# **Application for Licence Amendment**

**Licence Number** L7969/2004/3

**Premises** Paulsen's Gold Operation

**Revised Licence**

**Figure 1: Expanded Used Tyre Storage Area**

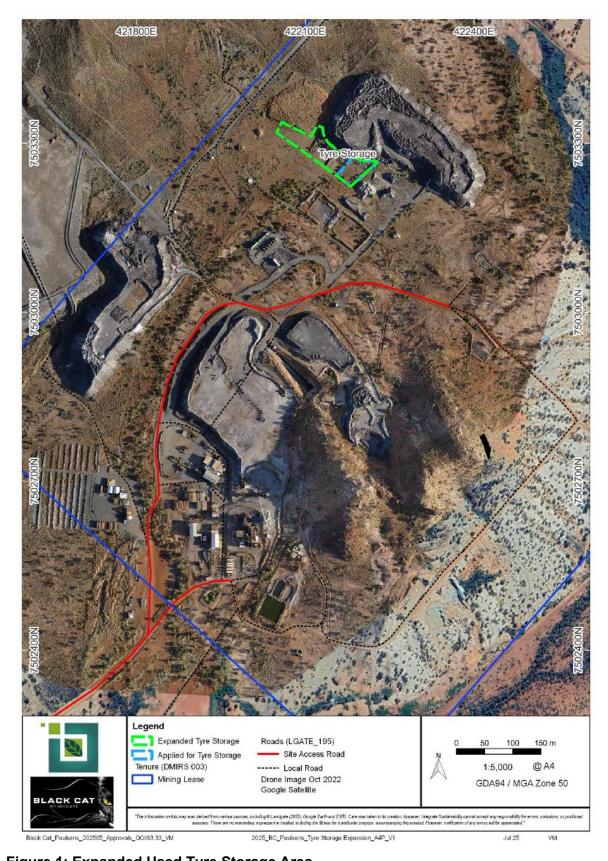
The Licence Holder currently stores less than 100 tyres at the Premises in the location shown in Figure 1 below. The used tyre storage area is located within a flat area, abutting the waste rock dump in a boundary that has been constructed with rock. The proposed licence amendment is to expand the tyre storage area to accommodate the storage of up to 200 used tyres at any one time which would meet the throughput capacity of prescribed premises Category 57: Used tyre storage. The tyre storage area will be graded to create surface water diversion/bunds to ensure all clean stormwater is diverted away from any potentially contaminated stormwater or firefighting water. The tyre storage area is located more than 100m from any hydrocarbon storage areas.

The Licence Holder has considered the standards for storage requirements set out in the Department of Fire and Emergency Service's (DFES) Guidance Note (GN02) on the 'Bulk storage of rubber tyres including shredded and crumbed tyres' and classified the storage of 200 tyres as a 'large tyre facility'. The Licence Holder has proposed a number of controls in accordance with the standards set out in the DFES GN02 to manage the risk of unauthorised fires and contaminated firefighting water and/or stormwater impacting upon nearby receptors as detailed in Table 1.
